Part Number: A071X163					 3D image provided when available for visual reference only.	
	Change Notice	CN00069931	Alternates				
	Manufacturer Part (MEP)	No	Usage	Production Only			
	Release Phase Code	Production (P)	Drawing Specification	Number: DS47102999			
	External Regulations	No External Regulation		Revision: D

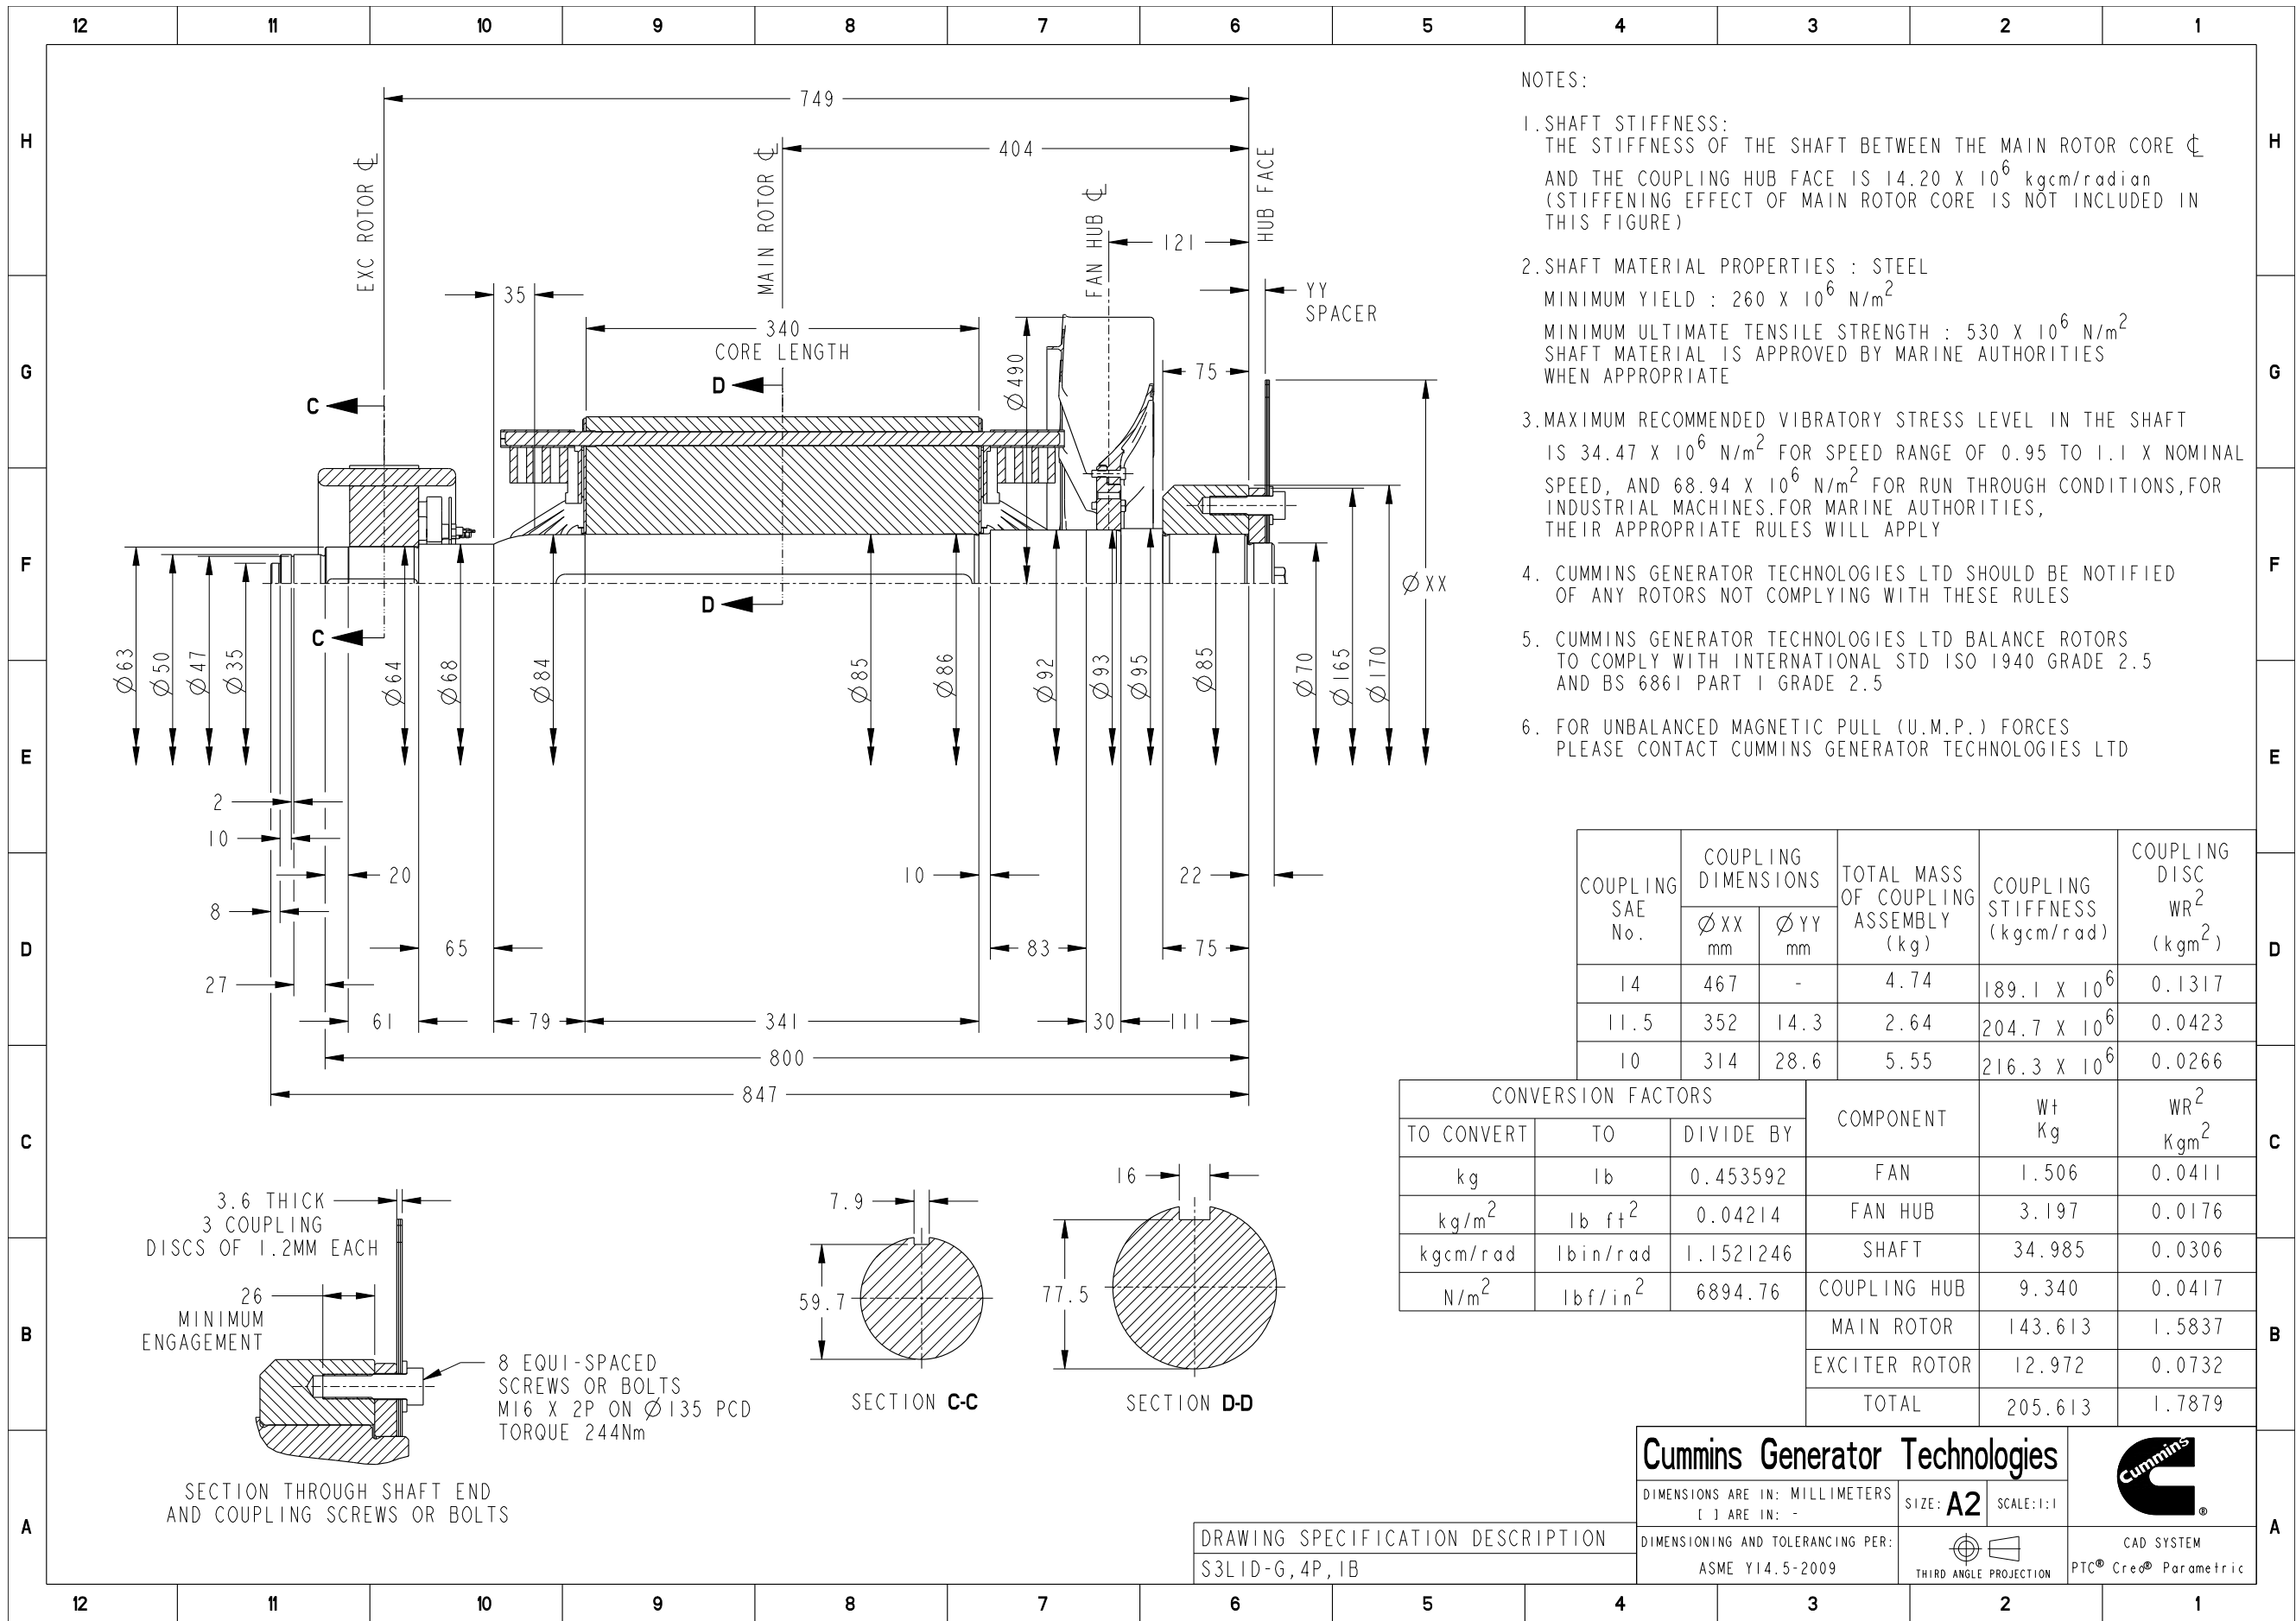
Drawing Revision Information							
Description of Change(s) Note: Change information is provided for reference only and does not supersede the drawing's primary content. 1.ZONE C/2,1 IN TABULATION FAN HUB TOTAL WT. 3.197 WAS 1.490 2.ZONE B,C/2,1 IN TABULATION SHAFT TOTAL WT. 34.985 WAS 35.086 3.ZONE B/2,1 IN TABULATION COUPLING HUB TOTAL WT. 9.340 WAS 8.356 4.ZONE C1, IN TABULATION FAN HUB INERTIA 0.0176 WAS 0.087 5.ZONE B/C,1 IN TABULATION SHAFT INERTIA 0.0306 WAS 0.0309 6.ZONE B/1 IN TABULATION COUPLING HUB INERTIA 0.0417 WAS 0.0374 7.ZONE D/7, DIM 83 WAS 78 & DIM 30 WAS 35 8.ZONE H/6,7, DIM 121 WAS 128 9.ZONE E,F/8 DIM 86 WAS 91 10.ZONE D/6 DIM 75 WAS 72 11.ZONE H/1,2,3,4 SHAFT STIFFNESS 14.21 WAS 14.20 12.UPDATE VIEW PICTORIALY ADMINISTRATIVE CHANGE(S) TO PART ATTRIBUTES, BILL OF MATERIAL, OR ASSOCIATED SPECIFICATIONS.
